Service Bulletin

Subject: WATER ACCUMULATION IN FOOTWELL / PLUGGED SOFT TOP DRAINS	Bulletin No:	09-046/10
	Last Issued:	10/15/2010

- This bulletin supersedes the previous bulletins 09-001/07 issued on 04/17/07, 09-021/09 issued on 04/06/09, 05/15/09 and 07/17/09. The PARTS INFORMATION has been revised.
- Changes are noted below in Red beside the change bar.

DRAIN COVER FILTER INSTALLATION

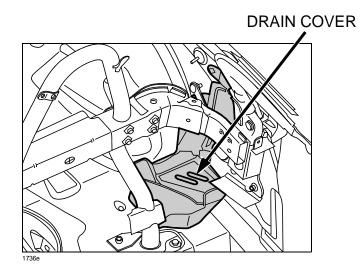
3. Peel the adhesive backing sheet from the filter and affix it to the bottom of the drain cover.

INSTALL THE FILTER TO THE DRAIN COVER AS SHOWN

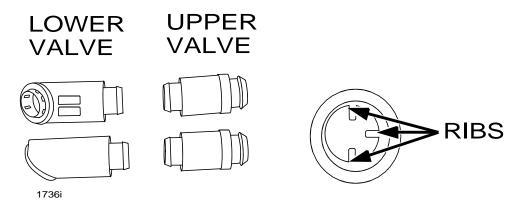
- 2. Replace the upper and lower valves with modified ones.
 - **NOTE:** The modified valves can be identified by the ribs inside the valve.

3. Install the modified lower value in the same position as the old value when removed.
